# INNER WEST

## DEVELOPMENT ASSESSMENT REPORT

<b>Application No.</b>	DA/2022/1090
<b>Address</b>	10 Lynch Avenue ENMORE NSW 2042
<b>Proposal</b>	Partial demolition of existing structures and to carry out ground and first floor alterations and additions to a dwelling house
<b>Date of Lodgement</b>	14 December 2022
<b>Applicant</b>	Ms Miranda G King
<b>Owner</b>	Mr Henrik M Hansen Ms Miranda G King
<b>Number of Submissions</b>	Initial: 21
<b>Value of works</b>	\$800,000.00
<b>Reason for determination at Planning Panel</b>	Number of submissions
<b>Main Issues</b>	Solar Access and Overshadowing Consistency of new openings with Heritage Conservation Area
<b>Recommendation</b>	Approved with Conditions
<b>Attachment A</b>	Recommended conditions of consent
<b>Attachment B</b>	Plans of proposed development

*Figure 4: View of eastern side elevation kitchen window at 8 Lynch Avenue (provided by Occupant submission)*

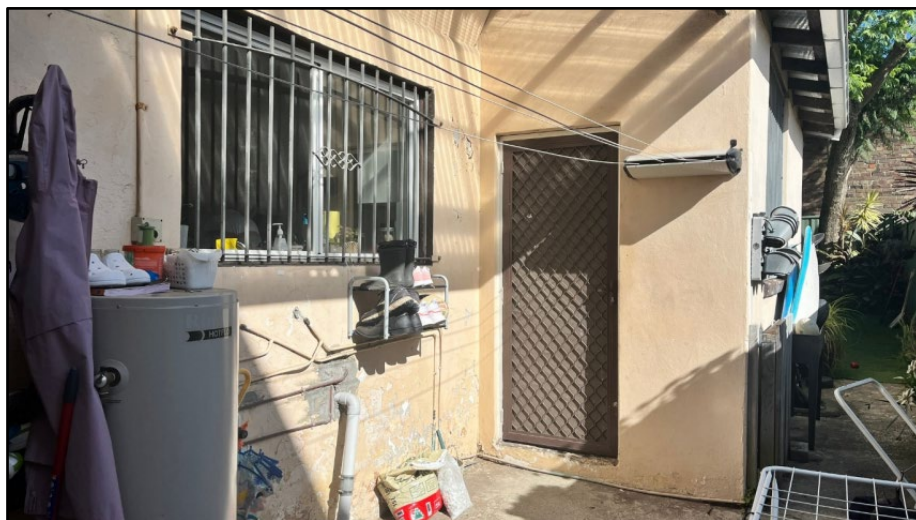
The proposal results in additional impact to the neighbouring residential dwelling at No. 8 Lynch Avenue. Council received various submissions relating to overshadowing impacts to this dwelling. Specifically, this adjoining property has solar panels on the rear plane of the two storey dwelling and on the skillion roof of the rear addition. The rear addition is 'L-shaped' with a small courtyard shaded with a translucent sheeting roof. There are two ground floor windows and a door in the single storey addition facing the subject site: a kitchen door and kitchen window in the alcove and a second window (which the applicant has indicated as a store, but the adjoining landowner refers to as a 'granny flat'/fourth bedroom). There is a third ground floor window (living room) on the rear of the original dwelling located within the alcove under the translucent sheeting roof. It is noted that the clothes line facilities are erected across the alcove between the subject windows and the side boundary of the dwelling. The following assessment relates to the principal living area windows only (kitchen and living).

ARCHITECT: DA 14  
PROPOSED GROUND FLOOR

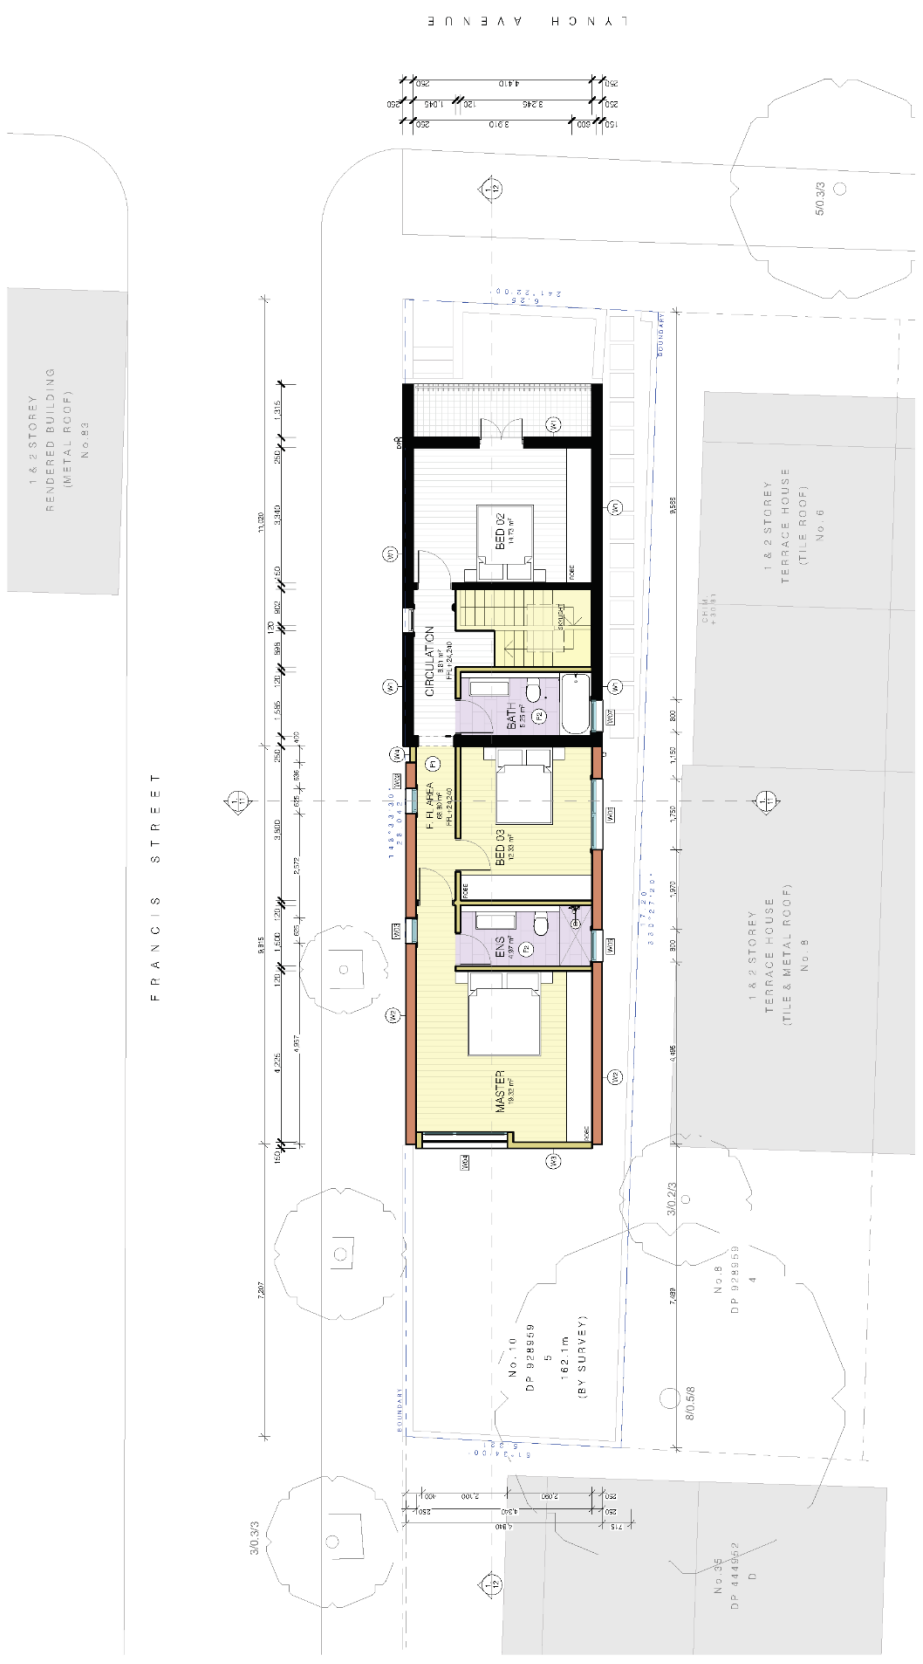
- The square window to the north elevation of the master bedroom on the first floor (W04) is not supported as this will be visible from the public domain and is not complementary to characteristic fenestration in the HCA. It is recommended that a design change condition be included in the consent requiring that this window be amended to be vertically proportioned window to match the dimensions of the windows

- a) *The square window to the north elevation of the master bedroom on the first floor (W04) must be amended to be vertically proportioned window to match the dimensions of the windows in the east elevation of the rear addition, employing traditional design (timber sash) and materials (timber frame).*
- b) *Delete the large skylight proposed in the western roof plane of the main roof form above the staircase (SKY01).*
- c) *The finish to the first floor north elevation (W3) be in horizontally laid timber weatherboards. The elevation and the Materials Schedule must be updated accordingly.*

- a. The square window to the north elevation of the master bedroom on the first floor (VV04) must be amended to be vertically proportioned window to match the dimensions of the windows in the east elevation of the rear addition, employing traditional design (timber sash) and materials (timber frame).
- b. Delete the large skylight proposed in the western roof plane of the main roof form above the staircase (SKY01).
- c. The finish to the first floor north elevation (W3) be in horizontally laid timber weatherboards. The elevation and the Materials Schedule must be updated accordingly.
